ARCHITECTURAL DESIGN COMPETITION REPORT

4-6 BLIGH STREET, SYDNEY

2 MAY 2019
PREPARED FOR ONE INVESTMENT MANAGEMENT PTY LIMITED ATF RECAP IV
MANAGEMENT NO. 4 TRUST

Figure 5 – Indicative Birds-eye Perspective of the Bates Smart scheme

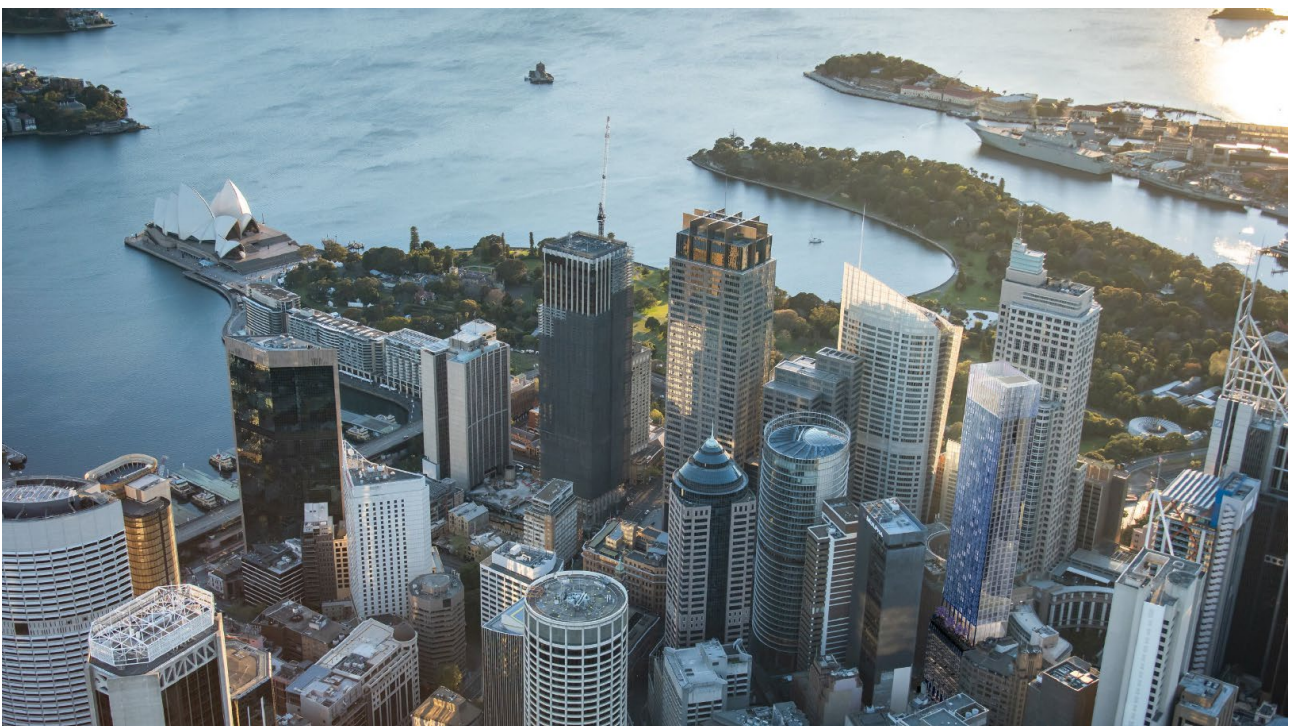
While the façade proposition was considered positive, it was considered that further volumetric resolution to the corners with regard to the two façade types was needed.

The innovation behind the modular hotel rooms was supported, however it resulted in narrow rooms with conventional layouts that were considered less innovative. It was considered that there was a greater focus on the façade than on the functionality and planning housed behind the façade.

Figure 7 – Indicative Birds-eye Perspective fjmt + SHARA scheme

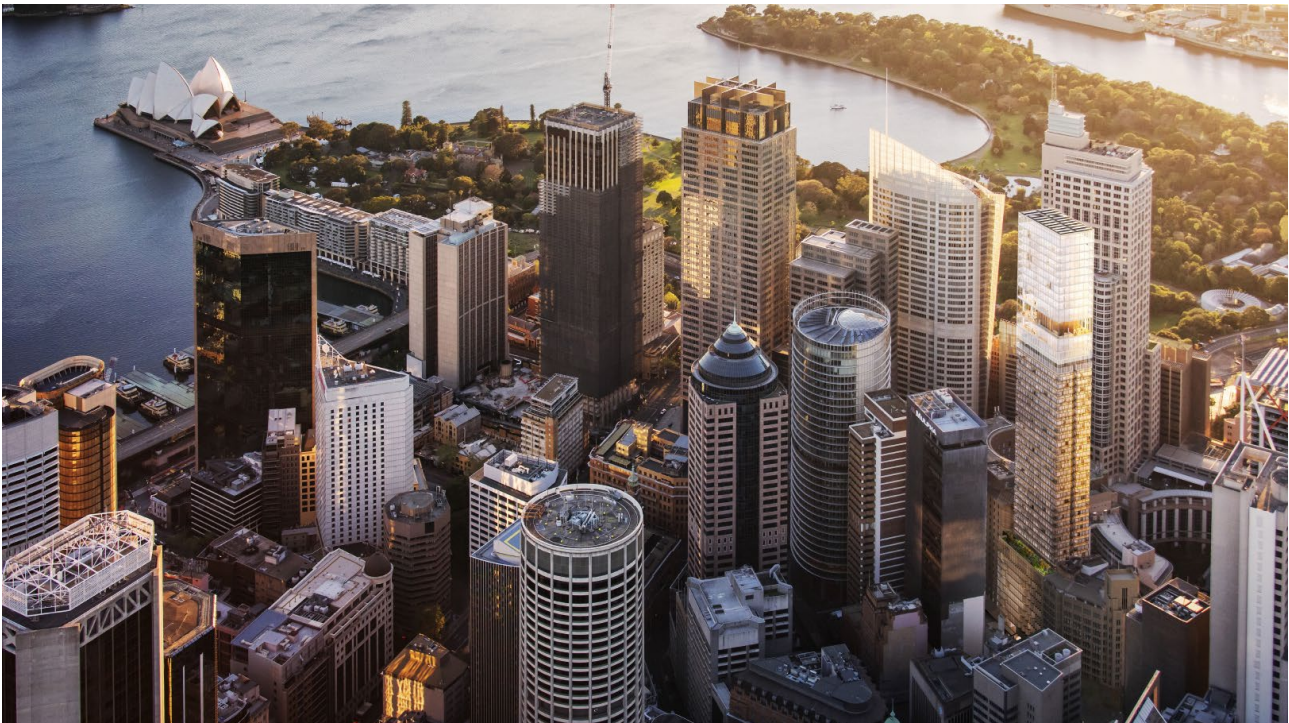
The fjmt + SHARA scheme proposal emerged from a close analysis of the site and its urban condition. The distinctive form of the podium facade was commended by the Jury for its relationship to the adjacent heritage facade and for its reading from the street, particularly with the CML Building. The awning treatment and continuation and height variations was a positive contextual response. The architectural expression was strong and clear and established two related but identifiably different architectural languages appropriate to the podium and tower.

The general arrangement of typical floors was efficient and well resolved. Natural light and air to common circulation spaces was achieved on these typical floors.

The sky lobby was considered to produce some inflexibility in the planning of the hotel and its operation.

Figure 9 – Indicative Birds-eye Perspective of the PTW + Collins & Turner + March Studio scheme

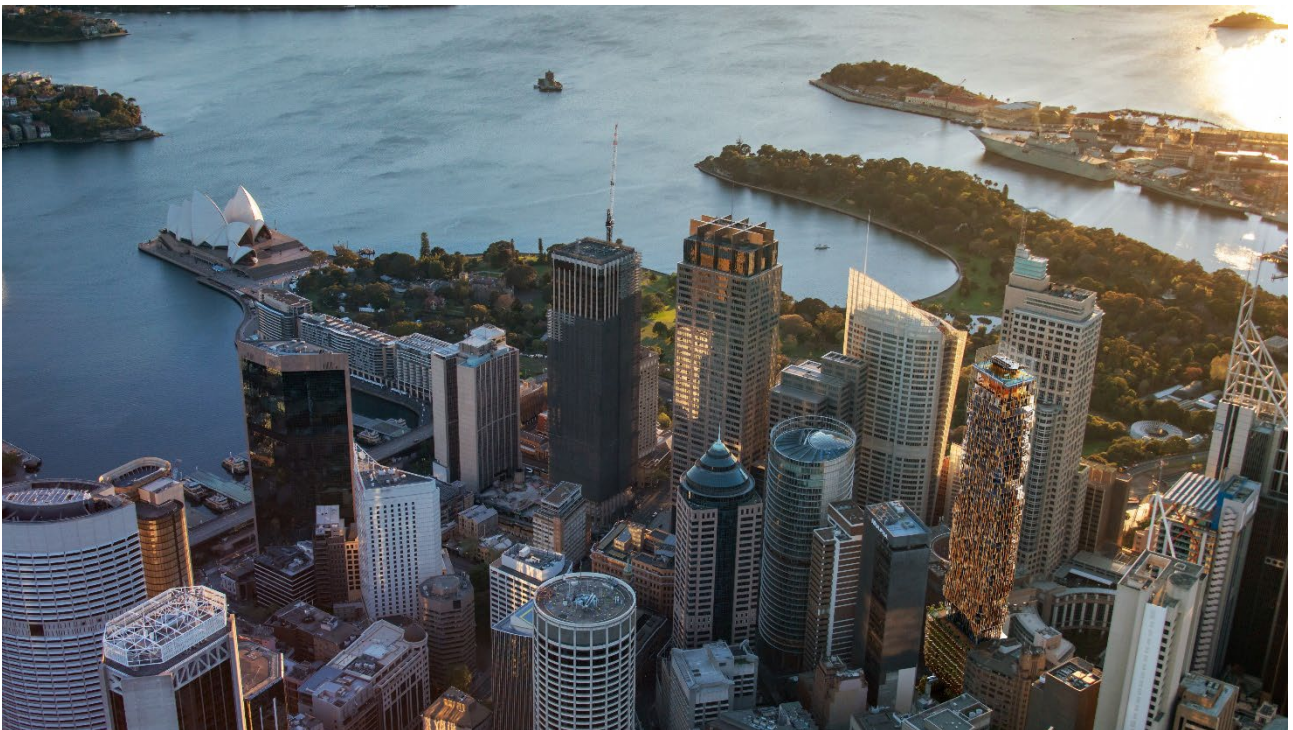
The generous space at ground on Bligh Street was noted as a positive activation outcome but the Jury were unsure as to how this would be used in operation.

The experiential elements of the design were deemed most successful, particularly the evocative reference to nature with the Rooftop Rock Pool and the Emerald Pool/Grotto.
